TRANSMITTAL MEMO

**Re: Partial Sufficiency and Further Action Determination under
WAC 173-340-515(5) for the following Hazardous Waste Site:**

- Name: Eddon Boat Park
- Address: 3711 and 3805 Harborview Drive, Gig Harbor, WA
- Facility/Site No.: 1301959
- VCP No.: SWO688

(Response to Technical Memorandum No. 4)

Figure 1
 Completed Actions
 Eddon Boalyard Property

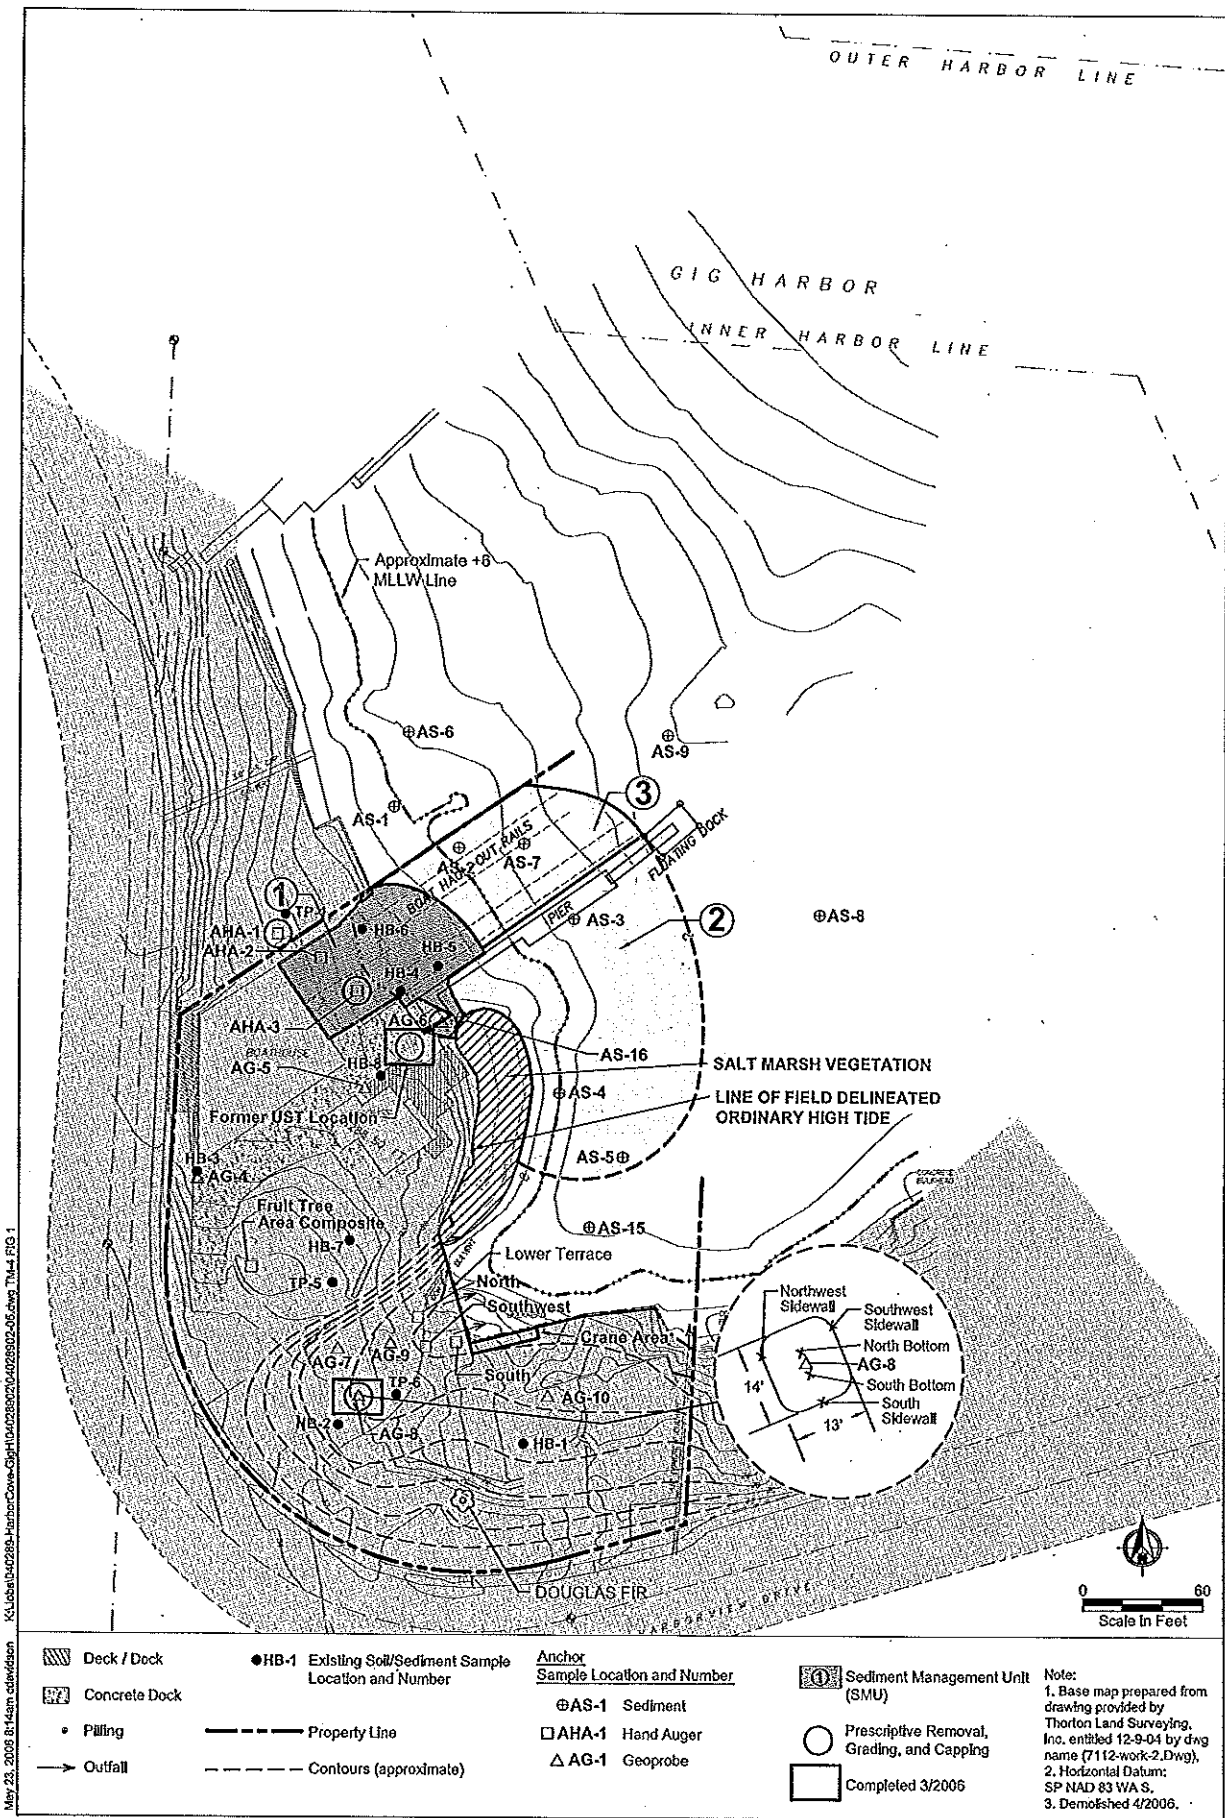
AHA-1 Area: A sample from location AHA-1 (1.5- to- 3-foot depth) had a concentration of 384 total carcinogenic polycyclic aromatic hydrocarbons (CPAHs); this value exceeds the Model Toxics Control Act (MTCA) Method A Cleanup Level for unrestricted land use. This sample location is just outside of a door on the north wall of the boat repair building, where it is reported that some disposal or storage of chemicals occurred in the past. *Assessment and remediation of this area needs to be performed.*

Heating Oil Underground Storage Tank: A sample from location AG-5 (1.0- to- 2.5-foot depth) near the heating oil underground storage tank (UST) adjacent to a residence (former Hoppen house) had a concentration of 417 total CPAHs; this value exceeds the MTCA Method A Cleanup Level for unrestricted land use. This UST was subsequently removed; upon removal of the tank, approximately 0.5-feet of water was present at the bottom of the 4-foot deep excavation. Soil samples were collected on the north, south, east, and west sidewalls (2.5-foot depth), at the bottom center, and a five-point composite from the soil stockpile for analysis of petroleum hydrocarbon identification (HCID), total petroleum hydrocarbons – gasoline range (TPH-G), total petroleum hydrocarbons – diesel range (TPH-D), and semi-volatile organic compounds. A water sample was also collected. All of the sidewall samples were below the Cleanup Level. However, the soil and water samples from the bottom of the excavation exceeded the Cleanup Level for TPH-G and TPH-D and the soil stockpile sample exceeded the level for cPAHs. The water from the excavation bottom was pumped to a 55-gallon drum for disposal and the excavation was deepened an additional 3-feet and a bottom sample was collected; all results for the above constituents were below the cleanup level. Water was initially not present at the bottom of the excavation but after a period of four days, water was present. A sample of this water showed no detectable TPH-G, TPH-D, or cPAH results.

Heating Oil Aboveground Storage Tank: A heating oil aboveground storage tank (AST) was formerly present at the west end of the boat building. Petroleum hydrocarbon contamination was reported from a soil boring adjacent to the AST (boring HB3). The previous Opinion Letter stated that additional characterization in this area was necessary. *Assessment and remediation of this area still needs to be performed.*

AG-8 Area: A sample from location AG-8 (0- to- 0.5-foot depth) in the gravel parking area behind the former city maintenance building had concentrations of TPH-O (2,160 milligrams per kilogram [mg/kg]) and lead (586 mg/kg) that exceeded the MTCA Method A Cleanup Level for unrestricted land use (cPAHs were not detected). The next sample, from the 1.5 – 3 foot depth, contained only 4 mg/kg lead. Nearby sample AG-7 5 (0- to- 0.5-foot depth) also contained detectable TPH-O (1330 mg/kg); however, this result is below the Cleanup Level of 2000 mg/kg. A 13-foot area was excavated around the AG-8 location to a depth of 2-feet below grade. Discrete confirmation soil samples were collected from the sidewalls (three samples) the bottom (two samples) for TPH and lead; all results were below the Cleanup Level.

AG-9 Area: A sample from location AG-9 (8.0- to- 10-foot depth) had a concentration of 378 total cPAHs; this value exceeds the MTCA Method A Cleanup Level for unrestricted land use. The source of the cPAH contamination at AG-9 was tentatively identified as creosote and therefore may be from a buried timber. *Assessment and remediation of this area needs to be performed.*

Groundwater: Groundwater was obtained from five of the push-probe borings (AG-4, -5, -6, -9, and -10). Since the pathway of concern for shallow groundwater on this site is most likely to be discharge to surface water, groundwater concentrations were compared to the appropriate water quality criteria (Washington State Marine Water Quality Criteria (WAC 173-201A), and the Clean Water Act Section 304 criteria for human health if available). However, a potability evaluation of groundwater should be performed to determine if drinking water standards apply.

- Selected metals results in groundwater at AG-4, -6, and -9 are above Marine Water Quality Criteria (WAC 173-201A). Locations AG-6 and -9 exceed these criteria for zinc and lead; locations AG-4, and -6 exceed the copper criteria; and mercury was above the criteria at AG-6.
- Arsenic is slightly above the 5 parts per billion (ppb) Federal drinking water standard in AG-6 (6.7 ppb).
- Metals in groundwater are above the Federal human health criteria (Section 304 Clean Water Act, and/or National Toxics Rule) for arsenic in surface water (AG-4, -6, and -9) and mercury (AG-6).
- TPH is present in boring AG-9, at the south end of the site, slightly above the Method A standard for groundwater.

Groundwater monitoring wells should be installed so that additional assessment of groundwater concentrations can be performed.
